Project Name: Bayshore Hotel

Subject: **WATER AND WASTEWATER CAPACITY AVAILABILITY LETTER**
Bayshore Hotel – DRC R18058
3016 Bayshore Drive, Fort Lauderdale, Florida 33304

City of Fort Lauderdale
Public Works Department
Water and Wastewater Capacity Analysis

Figure 1 – City Water Atlas

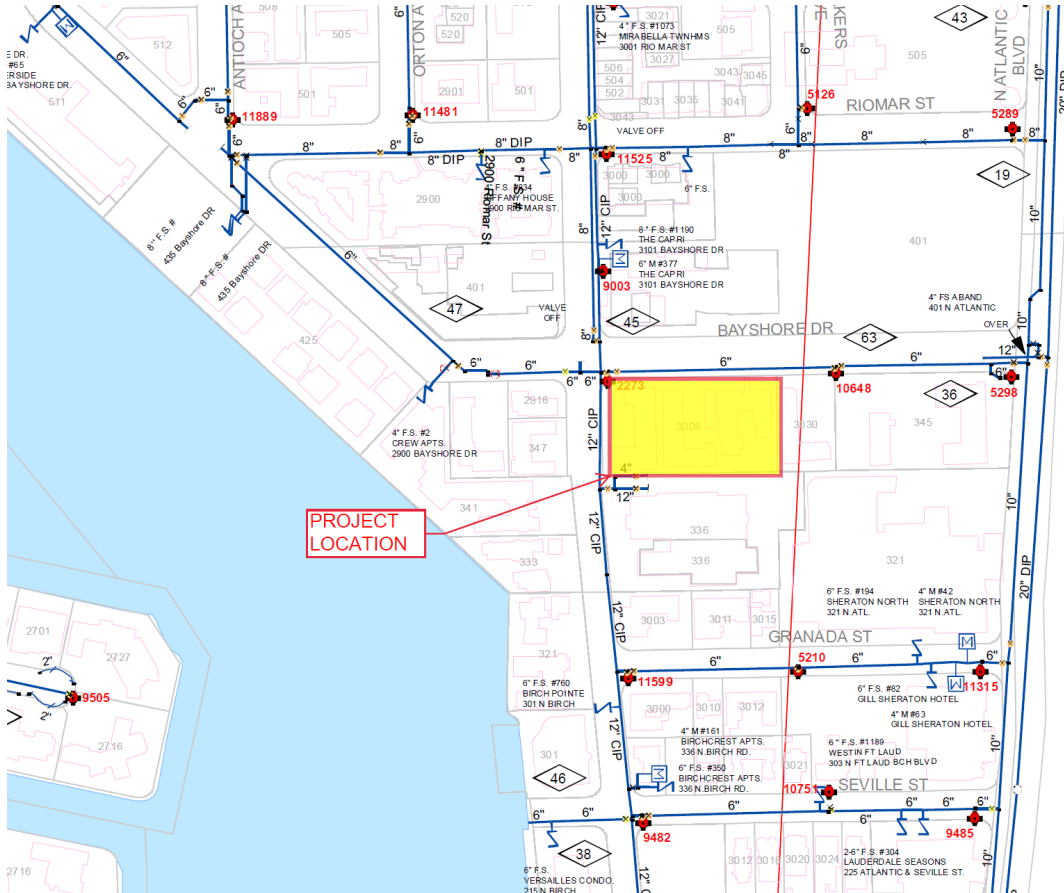
Water: The site is currently served by a 12-inch water main along North Birch Road, see Figure 1.

Evaluation of impact on existing distribution pipe (condition & capacity): According to the site plan, the applicant is proposing to utilize the 12-inch water main along North Birch Road. The InfoWater hydraulic model was analyzed to determine the impact of this project on the existing 12-inch water main.

Recommended Water Infrastructure Improvements: No improvements required.

Figure 3 – City Sewer Atlas

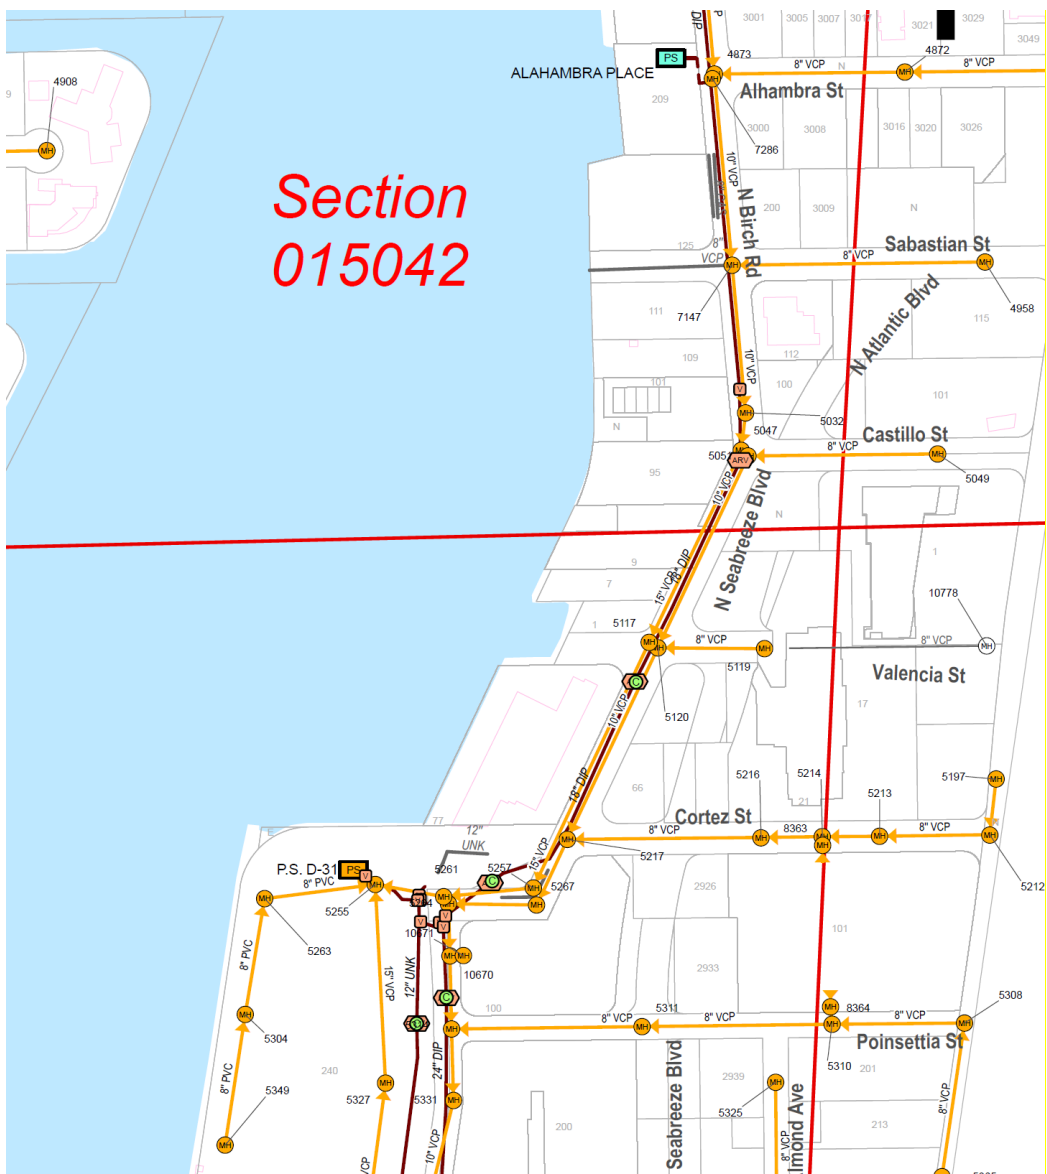
Wastewater: The site is currently served by an 8-inch gravity sewer main on Bayshore Drive and a 10-inch gravity sewer main on North Birch Road, which conveys flow downstream to a 15-inch sewer on North Birch Road and to pumping station D-31, see Figures 2 and 3.

Evaluation of impact on existing collection pipe (condition and capacity): According to the site plan, the site is currently served by an 8-inch gravity sewer main on Bayshore Drive and a 10-inch gravity sewer main on North Birch Road, which conveys flow downstream to a 15-inch sewer on North Birch Road and to pumping station D-31. Manual of Practice (MOP) 60, published by American Society of Civil Engineers (ASCE) for the gravity sewer design and used by the City staff, recommends that pipe diameters 15-inch or less be designed to flow half full during peak flows. The City uses a peak hourly flow factor of 3.0. Accounting for existing flows and based on the tools and information available to the City staff, it has been calculated that the 8-inch sewer on Bayshore Drive and the downstream 10-inch sewer on North Birch Road downstream of the proposed development will flow more than the ASCE-recommended 50% full during peak flows. Therefore, the pipes downstream of the developments do not have adequate capacity to serve the project.

Recommended Wastewater Infrastructure Improvements: The applicant will be required to upsize the existing gravity sewer system to handle proposed flow increase. It is recommended that the 8-inch gravity sewer on Bayshore Drive be upsized to 10-inch (approximately 250 feet), and the 10-inch sewer on North Birch Road downstream of the proposed development be upsized to 15-inch sewer (approximately 1,700 feet). A memorandum of agreement (MOA) shall be required between the City and the applicant to coordinate the design requirements and construction of the improvements.

Figure 4

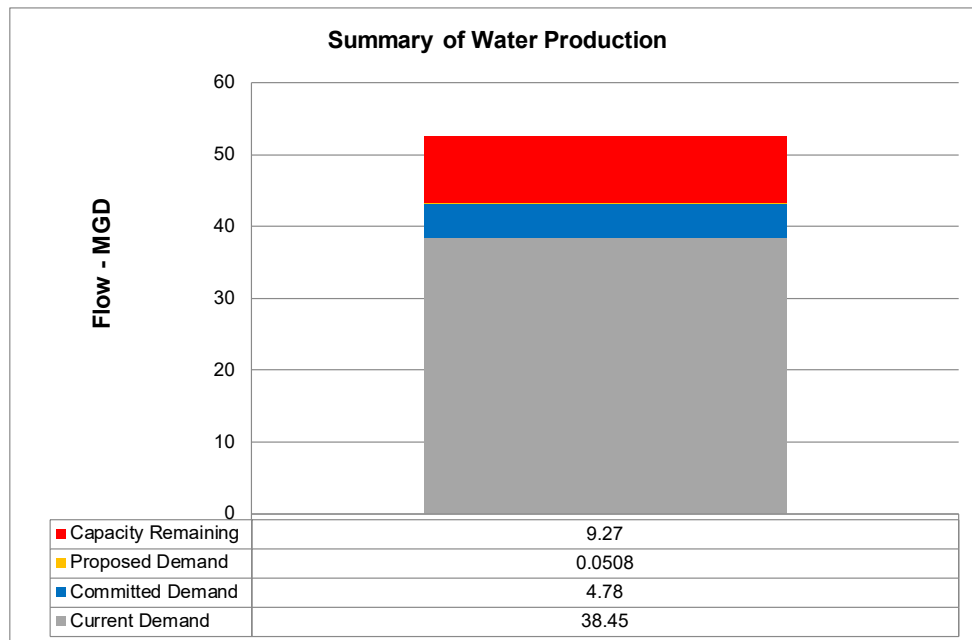
Evaluation of impact of Permitted Water Plant Capacity: The Fiveash and the Peele Dixie Water Treatment Plants are designed to treat 70 MGD and 12 MGD of raw water respectively (82 MGD total). The total permitted Biscayne aquifer water withdrawals for these plants is limited to 52.55 MGD per the South Florida Water Management District (SFWMD) permit number 06-00123-W.

The current twelve-month rolling average production at the two plants is 38.45 MGD. The previously committed demand from development projects in the permitting or the construction stage is 4.78 MGD. Combining these figures with the demand from the proposed project of 0.0508 MGD, the required production would be 43.28 MGD. This is less than the allowable withdrawal limit of 52.55 MGD. Therefore, the water plants have sufficient capacity to serve this project. See Figure 4 below.

Figure 5

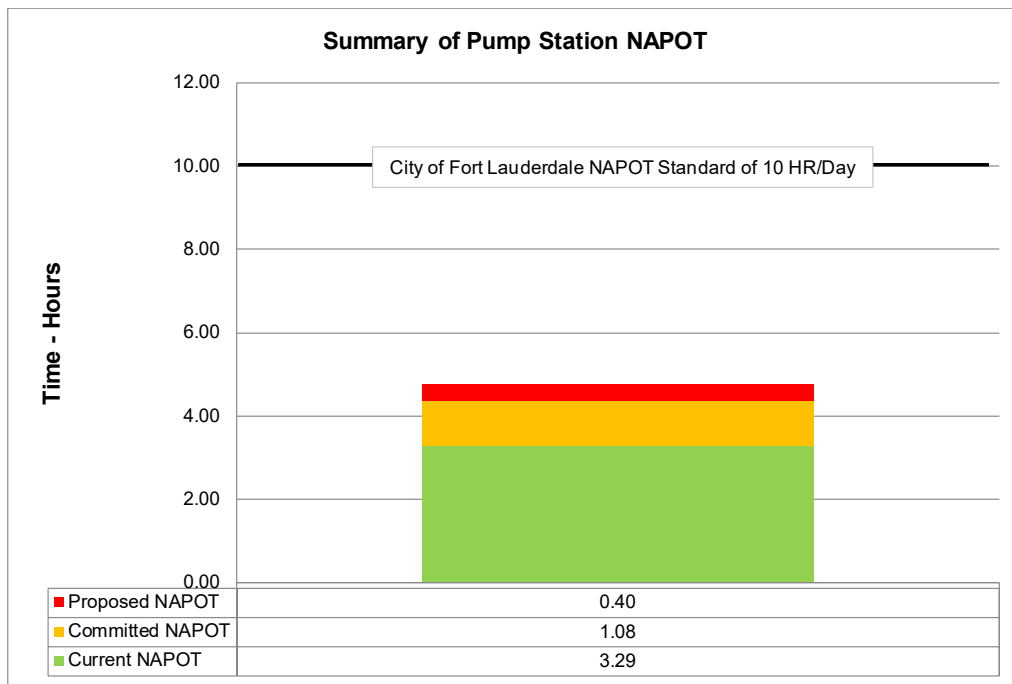
Evaluation of impact on pumping station: PS D-31 has a duty point of 1600 gallons per minute (GPM) and has a Nominal Average Pumping Operating Time (NAPOT) of approximately 3.29 hours per day. Based on projected sewage flows, the pumping run times would increase approximately 24 minutes per day. Additionally, there are other committed flows from proposed developments within the PS D-31 basin resulting in 64.65 minutes of additional runtime. PS D-31 will have a NAPOT of 4.77 hours once the proposed developments are complete, less than the recommended average of 10 hours per day. See Figure 5 below.

Figure 6

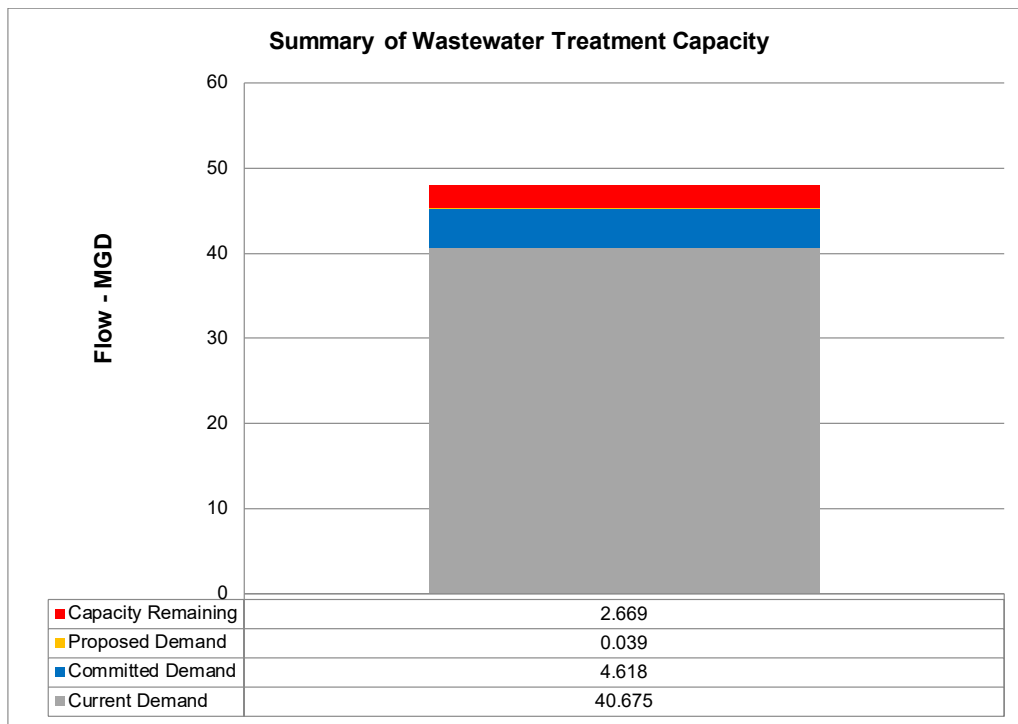
Evaluation of impact of Permitted Wastewater Plant Capacity: The City of Fort Lauderdale owns and operates the George T. Lohmeyer Regional Wastewater Treatment Plant (GTL), which provides wastewater treatment for the City of Fort Lauderdale. The Broward County's Environmental Protection and Growth Management Department's (EPGMD) Environmental Licensing & Building Permitting Division's licensed capacity for GTL is 48 MGD-AADF (Million Gallons per Day – Annual Average Daily Flow). The annual average daily flow (AADF) to the plant is 40.67 MGD. Combining the committed flows for previously approved projects of 4.62 MGD plus the 0.0386 MGD net contribution from the project results in a total projected flow of 45.33 MGD. This is less than the permitted treatment plant capacity of 48 MGD. Therefore, the treatment plant has sufficient capacity to serve this project. See Figure 6 below.
